Re: Bid # 08ITB59461K-JD W037 Hackett Road Elevated Water Tanks

Attached is one (1) copy of Addendum 1, hereby made a part of the above referenced Invitation to Bid # 08ITB59461K-JD W037 Hackett Road Elevated Water Tanks.

This Addendum forms a part of the contract documents and **modifies** the original documents as noted below:

TYPICAL PERVIOUS ASPHALT
CROSS SECTION
NTS

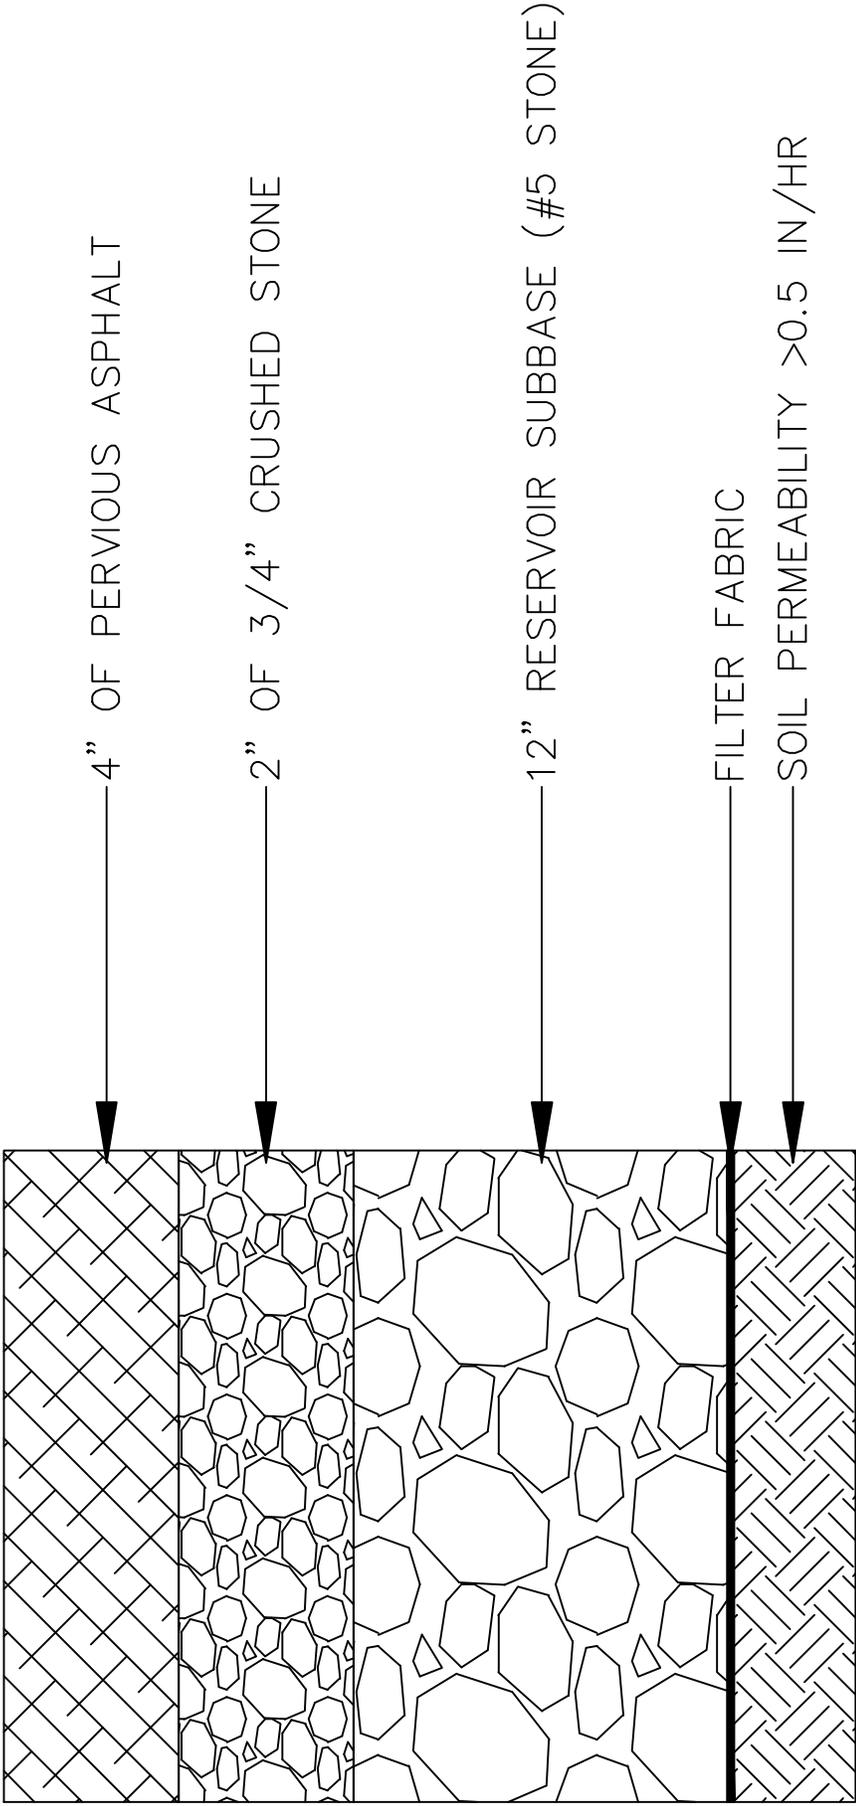
- Item 7: Sheet C7.0, Construction Details, add the attached sketch labeled “Typical Pervious Asphalt Cross Section” showing pervious asphalt paving detail.

- Response** See Modifications to the Specifications, Items 1 & 2.
- Question 6 Pavement is shown as "pervious" on Drawing C3.0, as "pervious concrete" on Drawings C6.0 and C7.0 but there is no specification for asphalt. Please clarify.

- Response** See Modifications to the Specifications, Item 4 and Modifications to the Drawings, Item 7.
- Question 7 Where is the pipe gate as detailed on Drawing C7.0 supposed to be installed?
